UNITED STATES PATENT AND TRADEMARK OFFICE

Office Action Summary	Application No. 10/696,830	Applicant(s) FATHALLAH ET AL.	
	Examiner GERALD LANDRY II	Art Unit 3763

DETAILED ACTION

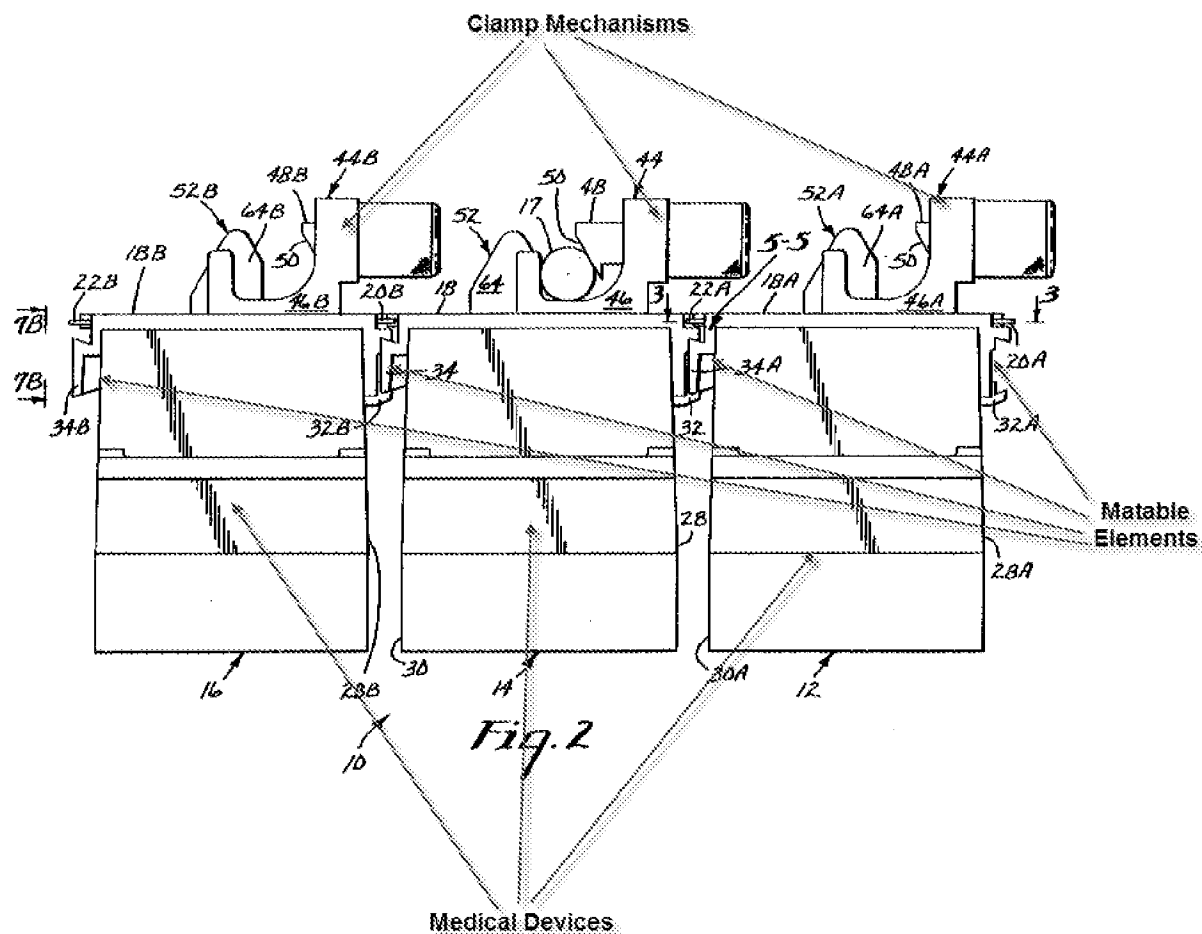
Regarding claims 4-7, 13, 15-19, and 75-77, Anderson teaches a plurality of medical devices including a first medical device and a second medical device; the first medical device including a housing having opposite sides, at least one of the opposite sides including a matable element; the second medical device including a housing having opposite sides, at least one of the opposite sides of the housing of the second medical device including a matable element for detachably interconnecting to the matable element of the first medical device and attaching the first and second medical devices; and wherein at least one of the medical devices includes a selective means for restricting the attachment of the second medical device to only one of the opposite sides of the first medical device housing; wherein the first medical device is provided with two matable elements, one matable element being located on each of the opposite sides of the first medical device housing; wherein the selective means includes a locking element which restricts attachment of the second medical device to the first medical device to only one of the opposite sides of the first medical device once the first medical device is attached to a support

member; wherein the first medical device includes a clamp mechanism for mounting at least one medical device to a support member; wherein the clamp mechanism has a hole therein for slidably receiving the locking element, the locking element adapted to apply force on a component of the medical device when the clamp body is affixed to a support member; wherein the clamp mechanism has a slide-ratcheting means for permitting a user to close the clamp mechanism about the support member by application of linear force to the clamp mechanism **(refer to marked-up figure below)**; wherein at least one of the medical devices includes a blocking means **(column 4 lines 9-25 (first position of latching arm))** for preventing a third medical device from attaching to either the first or second medical devices once the first and second medical devices are attached; wherein at least one of the medical devices includes a latch element **(26, 38, also refer to mating elements in marked-up figure below)** which detachably locks the first and second medical devices together once the first and second medical devices are attached; wherein a release element is operatively associated with the latch element, the release element permitting a user to selectively disengage the latch element **(refer to marked-up figure below)**; wherein the first medical device includes the latch element, the first medical device is provided with two matable elements where one matable element is located on each of the opposite sides of the first medical device housing, and wherein the latch element extends from the first medical device housing side that is not adjacent the attached second medical device and is secured in a position which prevents a third medical device from being added to the first medical device once the first and second medical devices are attached **(refer to marked-up figure below)**; wherein the matable element on the first medical device includes a ramped portion allowing the matable element on the first medical device to mate with the matable

element on the second medical device when the matable elements are not precisely aligned (refer to marked-up figure below); wherein the matable element on the second medical device includes a tapered portion allowing the matable element on the first medical device to mate therewith when the matable elements are not precisely aligned (refer to marked-up figure below); wherein the matable elements are corresponding male T-slides and female T-slots (refer to marked-up figure below).
